Service Bulletin

Bulletin No. 2012-08
OEM No. 2012-07

3000 Series Zeus Skeg Kit

Old **New**

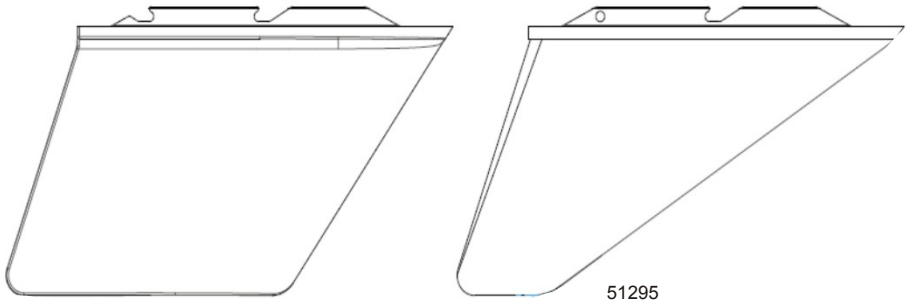
To resolve instances of skegs falling off due to the pin becoming loose and falling out, the Zeus 3000 skeg and pin have been redesigned to provide for improved retention. The angle of the leading edge of the skeg has been increased, and the pin has been changed from a roll pin to a solid pin design. This new skeg was implemented on pod serial number 0M968382.
